Access Compliance Report

Public Rights-of-Way

(Curb Ramps)

Intersection ID: 17504	Main Street: CORINTHIAN_PL	Cross Street: WALKER_RD	Location: SE
ADA ID: 582110C6AB65	Ramp Type: PerpDiag	Initial Pass/Fail: Fail	Overall Compliance: No
		Severity Score: 55

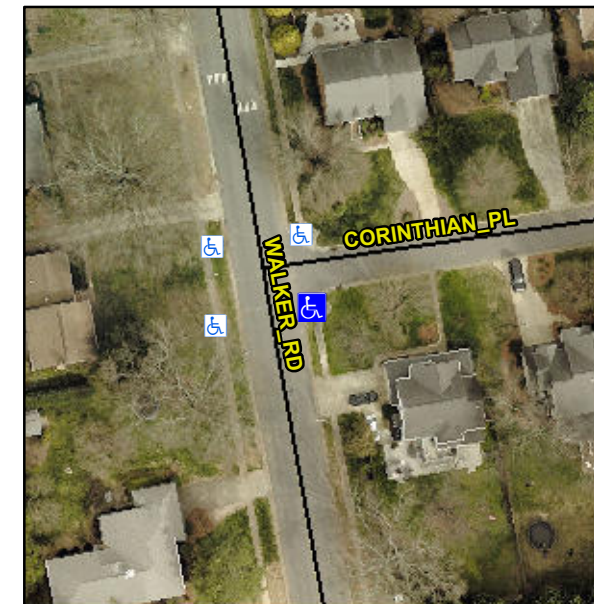
Not Found, R304.5.1, R304.2.2, R304.5.3

Compliance	Description	Data	Compliance	Description	Data
N/A	Ramp Length (in)	48.0	No	Ramp Slope (%)	10.4
No	Ramp Width (in)	34.0	No	Ramp XSlope (%)	7.7
N/A	Flare Type LT	N/A	N/A	Flare Type RT	N/A
N/A	Flare Slope LT (%)	N/A	N/A	Flare Slope RT (%)	N/A
N/A	Flare Traversable LT?	N/A	N/A	Flare Traversable RT?	N/A
N/A	Landing Length (in)	N/A	N/A	DWS Provided?	N/A
N/A	Landing Width (in)	N/A	N/A	DWS Contrast?	N/A
N/A	Landing Slope (%)	N/A	N/A	DWS Length (in)	N/A
N/A	Landing X Slope (%)	N/A	N/A	DWS Full Width?	N/A
N/A	Landing Curb? (Y/N)	N/A	N/A	DWS Offset (in)	N/A
N/A	Shared Landing?	N/A			
N/A	Gutter Ponding?	N/A	N/A	Gutter Slope (%)	N/A
N/A	Gutter Lip Ht (in)	N/A	N/A	Gutter X Slope (%)	N/A
N/A	Painted X Walk1?	No	N/A	Painted X Walk2?	No
	X Walk 1 Direction	To N		X Walk 2 Direction	To W
N/A	X Walk 1 Width (in)	N/A	N/A	X Walk 2 Width (in)	N/A
	X Walk 1 Slope (%)	2.8		X Walk 2 Slope (%)	6.8
	X Walk 1 X Slope (%)	6.0		X Walk 2 X Slope (%)	2.5

Remove & Replace Curb Ramp With Two New Directional Ramps or Equivalent.
